Model: Z-folding Unit ZF4000		Date: 8-Feb-08	No.: MB660A01
Modified Article: Main Board		Prepared by: H.Matsui	
From: 2nd Tech. Support Sec. Service Support Dept.			
Reason for Modification:	<input type="checkbox"/> Parts catalog correction <input type="checkbox"/> To facilitate assembly <input type="checkbox"/> Part standardization	<input type="checkbox"/> Vendor change <input checked="" type="checkbox"/> To improve reliability <input type="checkbox"/> Other	<input type="checkbox"/> To meet standards ()

Model: Z-folding Unit ZF4000	Date: 12-May-08	No.: MB660A03a
------------------------------	-----------------	----------------

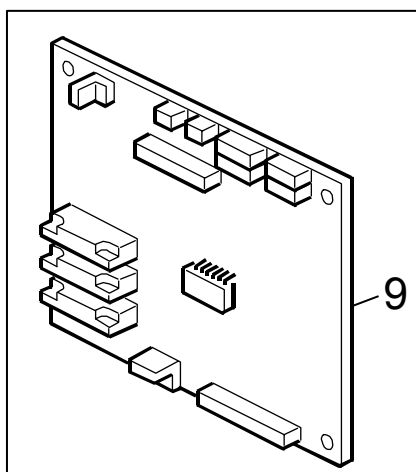
Old part number	New part number	Description	Q'ty	Int	Page	Index	Note
B6605547	B6605548	PCB Main Control	1	X/O	23	9	
	B6605510	EP-ROM	1	-	23	37*	New Index

Change:

- The following symptom was corrected:
The "Copying" message remains displayed if a jam occurs at the entrance of the Z-folding unit.
- EP-ROM was newly added as a service part.***

- To ensure this symptom does not occur.
- Requests were received from the field.
